**Subject: Transmittal of Class 1 Permit Modification Notification to Update Figures in the Los Alamos National Laboratory (LANL) Hazardous Waste Facility Permit, EPA ID No. NM0890010515**

Enclosure: 1) Class 1 Permit Modification Notification Structure Changes at Technical Area 54

## **Permit Modification Notification**

**Figure 35**  
 Technical Area (TA)-54, Area G, Building 33

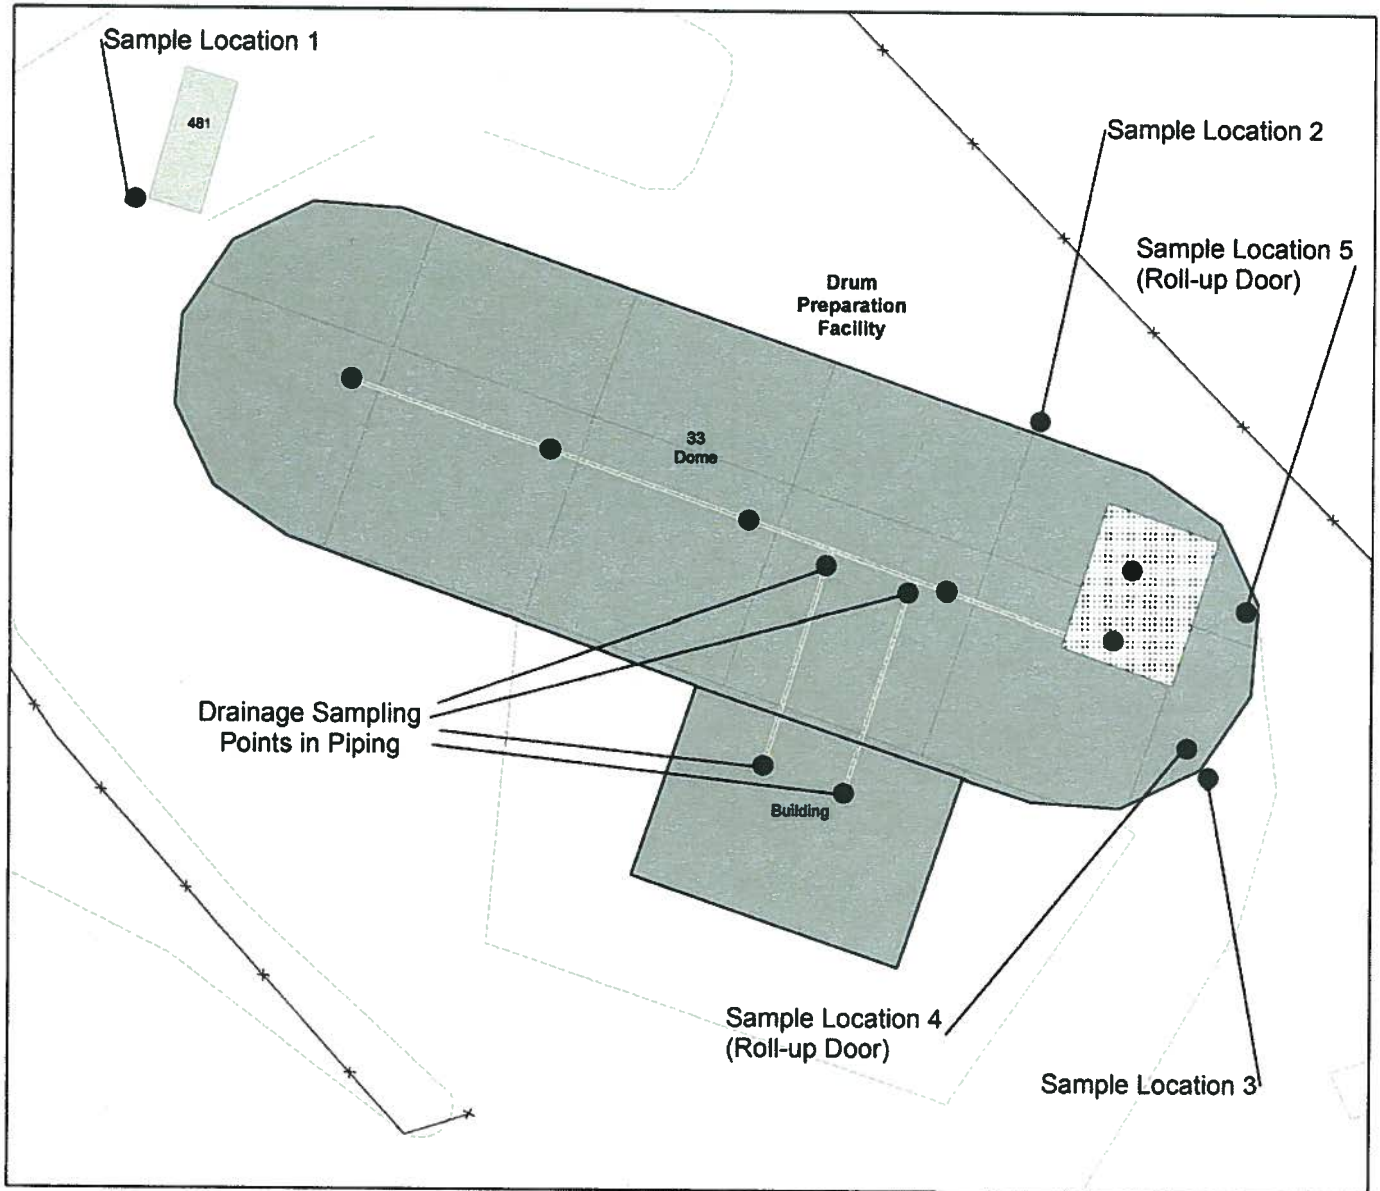
Figure 35 (Technical Area (TA)-54 Area G, Building 33) of Attachment N and Figure G.14-1 (Technical Area 54, Area G, Building 33, Indoor Container Storage Unit Grid Sampling and Additional Sampling Locations) of Attachment G.14 were revised to remove structure 377. This structure, which was relocated to Pad 1 to serve as a storage structure, is not associated with Permit activities or the management of hazardous waste.

Figure 27: Technical Area 54, Area G, Container Storage Units

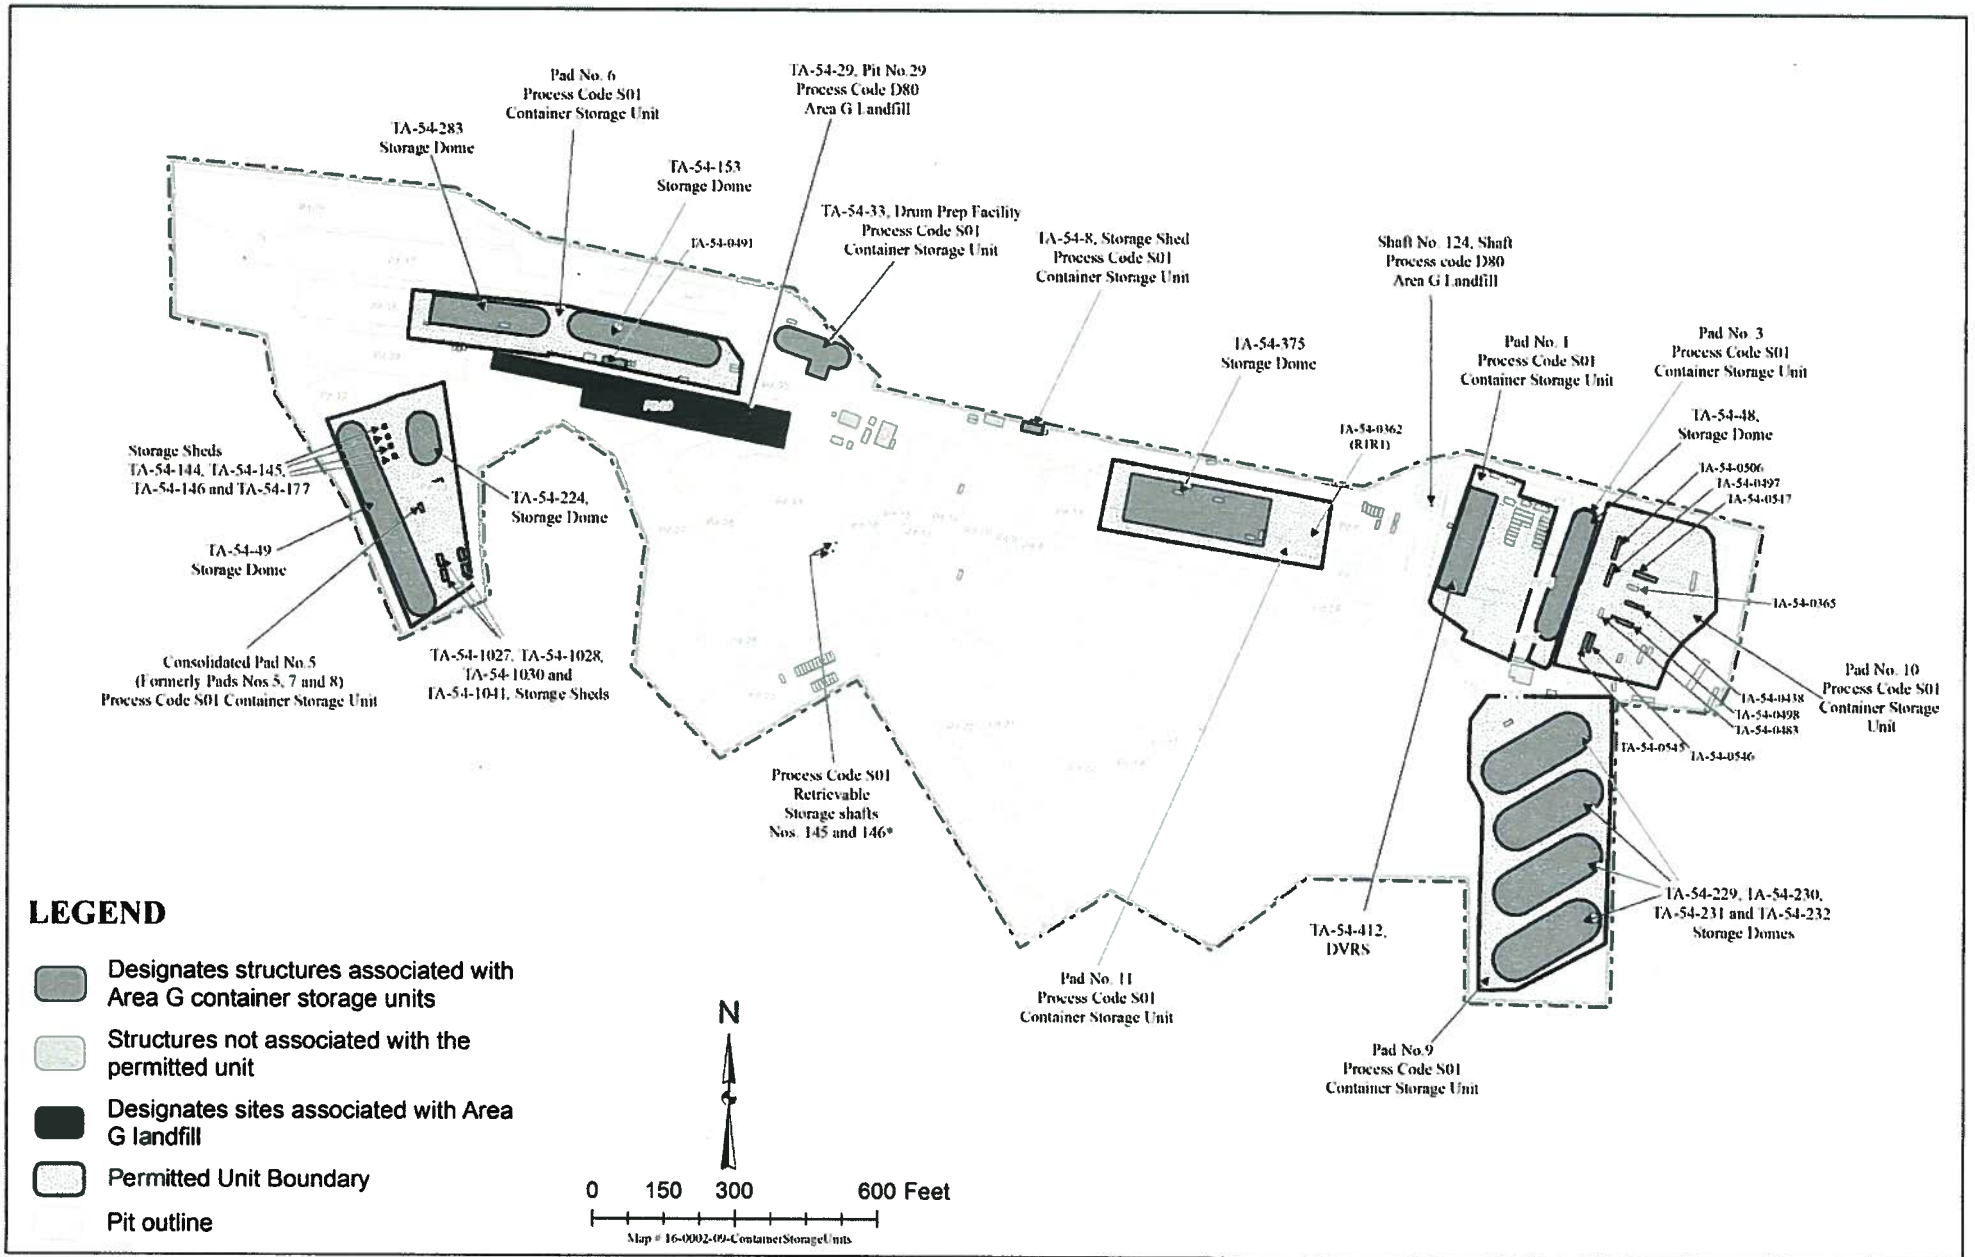
Figure 27 (Technical Area 54, Area G, Container Storage Units) of Attachment N was revised to reflect all of the changes discussed above and remain consistent with other figure updates. The changes to Figure 27 are as follows:

- On Pad 1, seventeen support structures were moved to the Pad. These structures will be used to store equipment and tools; they are not associated with the permitted unit and they will not be used to manage hazardous waste.
- On Pad 10, storage trailer TA54-1059 was removed and relocated to Pad 1. Storage trailer (54-484) and two additional support structures, which will be used to store equipment and supplies, were moved to the south east corner of Pad 10. These structures are not associated with the permitted unit and are not used to manage hazardous waste.
- On Pad 9, storage shed 574 was removed and relocated to Pad 1.
- Near Building 33, storage trailer 377 was removed and relocated to Pad 1.
